**RESOLUTION SETTING HEARING ON REQUEST FROM CASEY'S MARKETING COMPANY FOR APPROVAL OF PUD FINAL DEVELOPMENT PLAN FOR "CASEY'S STORE NO. 1192" FOR PROPERTY AT 3200 SOUTHWEST 9<sup>TH</sup> STREET**

## PUD FINAL DEVELOPMENT PLAN FOR

# CASEY'S GENERAL STORE NO. 1192

SHEET  
 C-201

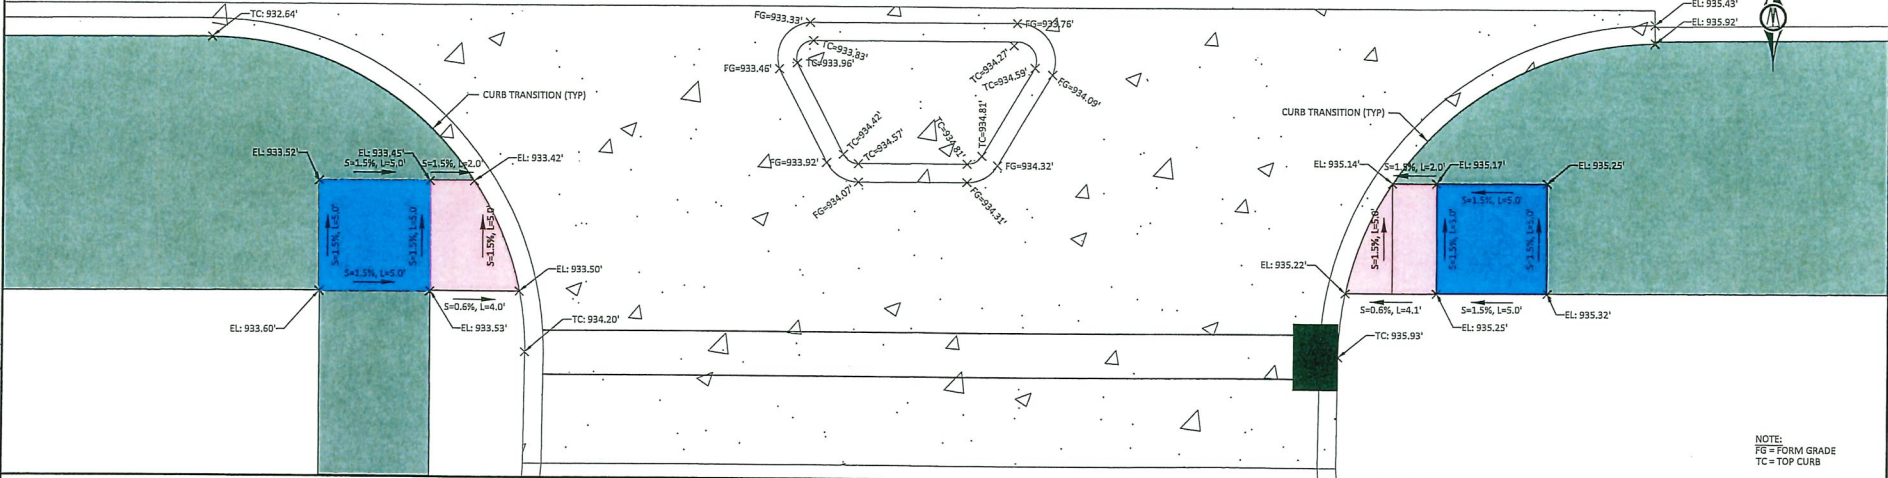
Underground stormwater storage chambers are proposed on the northwest portion of the site to manage required stormwater detention (see Sheet C-201 of submitted Final Development Plan). These chambers would outlet into public storm sewer available in Park Avenue at the northwest corner of the site.
